**Flood Control Project Maintenance  
Levee Inspections**  
**LMA District Cover Sheet**  
**Spring 2017 Levee Inspection Results**

**Sutter Maintenance Yard Wadsworth Canal**

**Levee Inspection Report By Mile - Spring 2017**

**Sutter Maintenance Yard Wadsworth Canal**

Photo 2 of 3 : UCIP\_SP\_2017\_51515\_64743.jpg

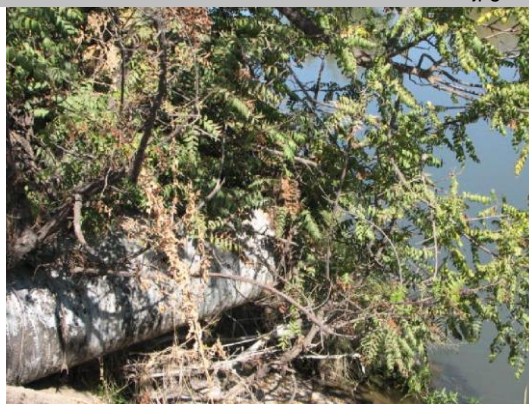
Comment Code						
Inspector Comment						
FS_ID:51515 DS_ID:17077 EP_NO: 7209 Repair Type: Non-Urgent Crossing Status: Found UCIP Comments: 4/10/2017 Tree still present and a problem at the WS pipe outlet. LS inlet is still vegetated. (DWR Sutter Yard-AFreitag)10/12/2016 Tree at the WS pipe end is still an issue and needs to be cut away. LS inlet is also being overgrown with vegetation.(DWR Sutter Yard - afreitag)4/19/2016 Tree at WS pipe end needs to be trimmed back and/or removed. 5/12/2015 Tree growing near WS pipe end is getting too big and will affect the crossing. It needs to be cut back or removed.11/18/2014 Same as last inspection.5/13/2014 Same as last inspection.10/29/2013 Same as last inspection.5/16/2013 Same as last inspection. FIELD_STRUCT_DESC: 36-inch corrugated metal drainage pipe (permit records indicate 30-inch pipe O&M pipe replaced with new 30-inch pipe) through the levee, 14 feet below the crown. Flap gate located on the waterside (WS) end. (original O&M manual crossing was replaced under Permit No. 7209, 1970 - Department of Water Resources) [Additional Reference(s): DWR Levee Log, 2005. USACE Sacramento O&M Manual 135, May 1953, (Station 158+35)]. FS Date: 4/12/2017 10:16:27 AM

Heavy vegetation at LS inlet at channel.
